IN THE MATTER of applications by Meridian Energy Limited to Manawatū-Whanganui Regional Council, Greater Wellington Regional Council, Tararua District Council and Masterton District Council for resource consents to enable the construction, operation, and maintenance of a new wind farm on Mount Munro, located approximately 5km south of Eketāhuna

SECTION 87F REPORT OF NEIL ANDREW CRAMPTON – GEOTECHNICAL

**MANAWATŪ-WHANGANUI REGIONAL COUNCIL, GREATER WELLINGTON
REGIONAL COUNCIL, TARARUA DISTRICT COUNCIL AND MASTERTON DISTRICT
COUNCIL**

15 March 2024

Figure 1: Indicative Fill Disposal Areas Plan, T+T Drawing No. 1016884.10000-016 titled Rev 3, Oct 23.

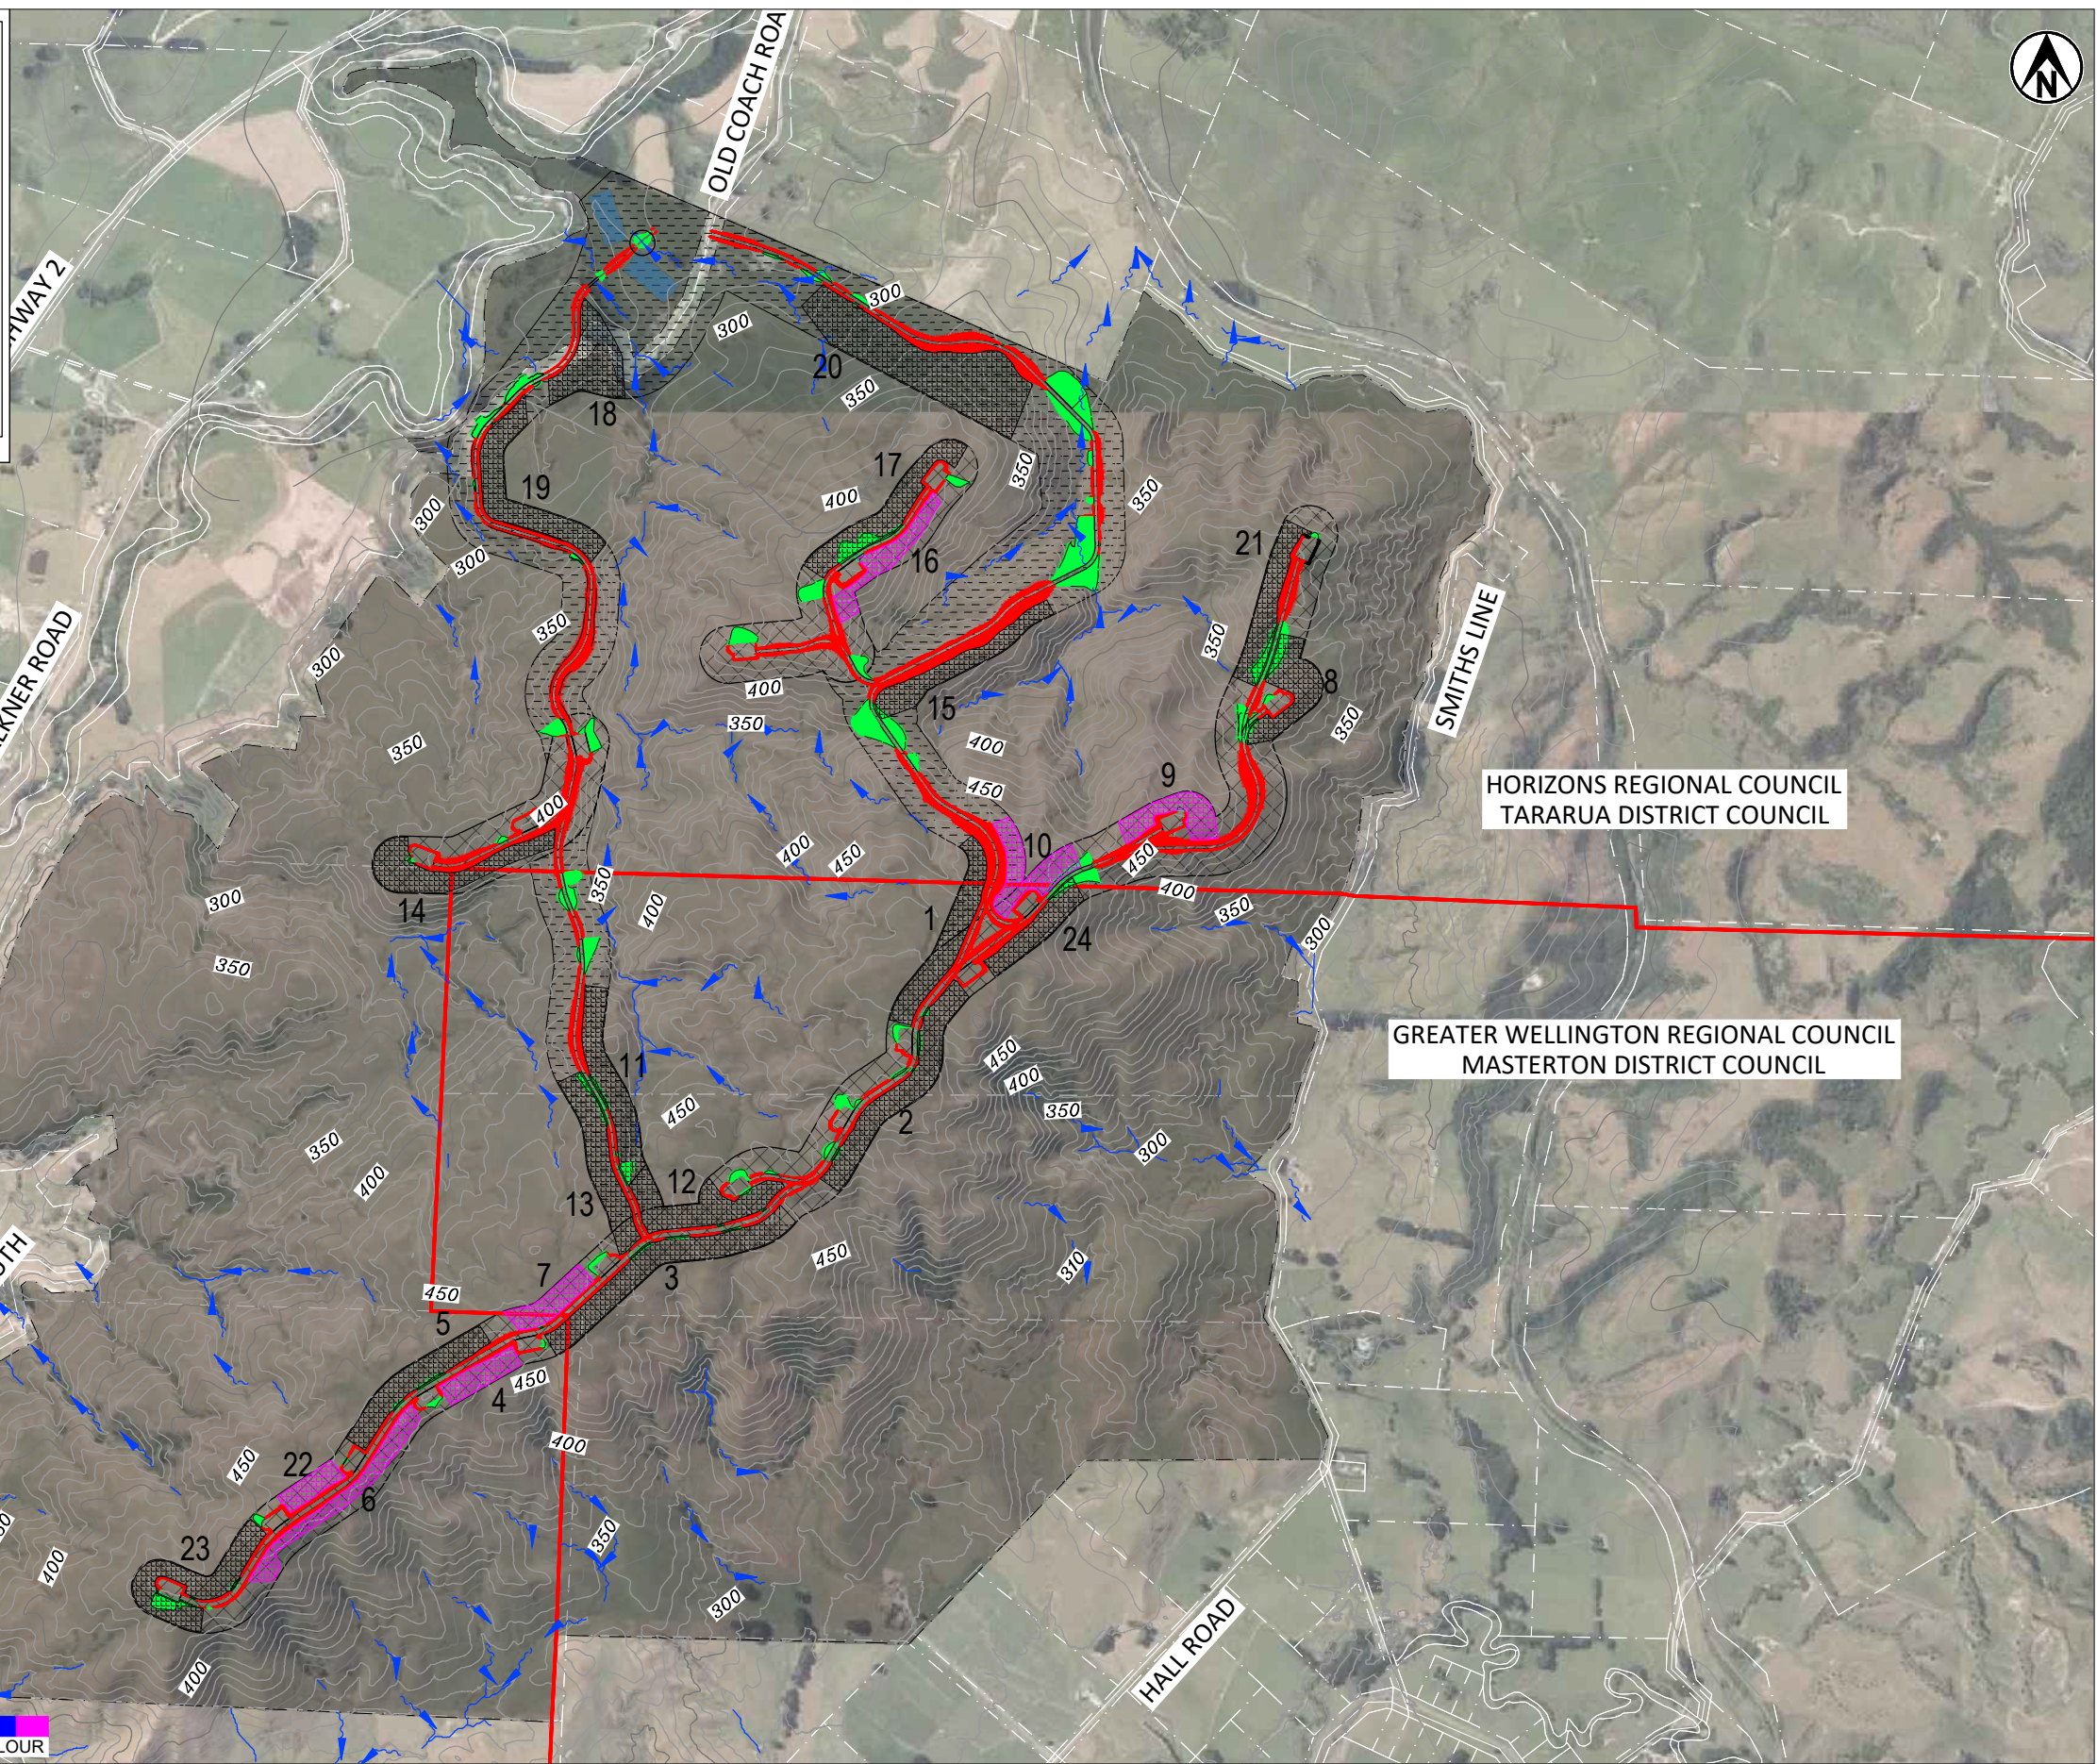
- 27 The RFI responses and direct discussion with the geotechnical specialist in relation to the location and footprint of the fill disposal sites has confirmed there is a maximum of approximately 1.4M m³ of excess fill requiring disposal. This accounts for the updating of fill disposal sites and footprints to accommodate the updated excess fill volume provided by the Applicant in Table 1 (reproduced above).

- 28 The finalised plan of excess fill disposal sites is **attached** as Figure 1 to this report. I am of the view that Figure 1 adequately represents the sites required to accommodate the indicated maximum excess fill that will be generated by the proposed earthworks for the project.
